DETAILED ACTION

Application/Control Number: 10/550,745
Art Unit: 3618

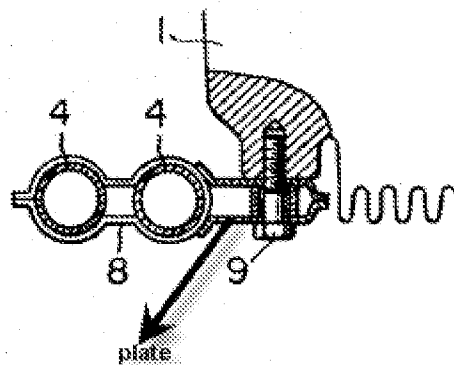
Shimada teaches a motor vehicle including a combustion engine (1), a gearbox, an exhaust system (2, 8) and an exhaust system bracket (21a) for fastening the exhaust system, characterized in that the exhaust system (2, 8) is fastened to the gearbox (5, 6) through the exhaust system bracket (21a) which comprises a supporting element (11, 11a) in the form of a plate holder with at least two band-like, elastic plates (11, 11a) which are superimposed so as to form a stack (as shown in Figures 5-7 which clearly illustrates the plates (11, 11a) arranged one on top of the other); and the plates (11, 11a) are able to move relative to each other on at least a part of their length because they are attached by fasteners and not integral. The supporting element has an angular structure as seen in the longitudinal section. The supporting element, as seen in the longitudinal section, has a twofold angular structure in the form of an offset step, as shown in Figure 7. The supporting element, as seen in the longitudinal section, has a fourfold angular structure in the form of two offset steps which are arranged mirror-inverted to each other, as shown in Figure 7. The plates have a smooth surface. The plates have a structured surface. Re claim 17, the supporting element is fastened to the

exhaust system by means of a supporting fixture/console (23). Re claim 18, see Figure 1 and bracket/mounting member (10). It is noted that Figures 7 and 8 are modifications to Figure 1; however, it is reasonable to interpret those elements not shown as modified to be the same in each embodiment. Re claim 19, as shown in Figure 6, the plates have corresponding cross-sections as seen in a longitudinal section. Re claim 20, as best understood, the bracket (21a) has a first end connected to the gearbox (5, 6) and a second end connected to the supporting element (plates 11, 11a), and each plate (11, 11a) of the supporting element has one plate end connected to the second end of the bracket (10) and an opposite plate end connected to the exhaust system (2, 8) via supporting fixture/console (23).

Aiba

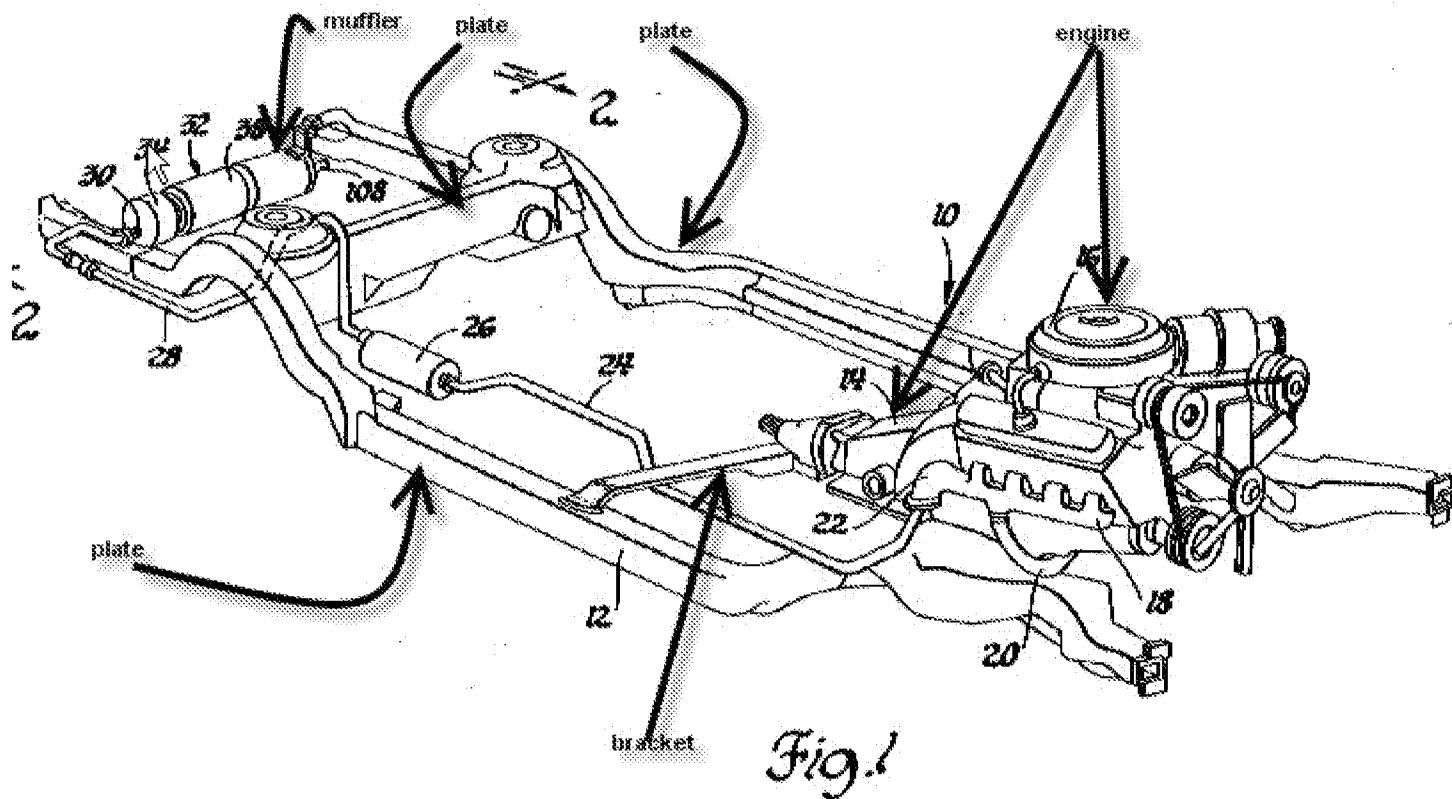
3. Claims 21 and 22 are rejected under 35 U.S.C. 102(b) as being anticipated by Aiba (US Patent 4,359,126).

Aiba teaches an exhaust system mounting assembly including: a bracket (8) having a first and second bracket portion (shown in the Figure as a top portion and a

bottom portion), the first bracket portion being adapted to be connected to an engine block (1) and a supporting element (note the separate structure labeled above connecting bracket 8 and component 9 in Figures 2 and 3) including a plurality of plates arranged in stacked relationship (one on top of the other), the supporting element having a first end connected to the second bracket portion and a second end connected to an exhaust component (9). The plates have corresponding cross-sections as seen in a longitudinal direction.
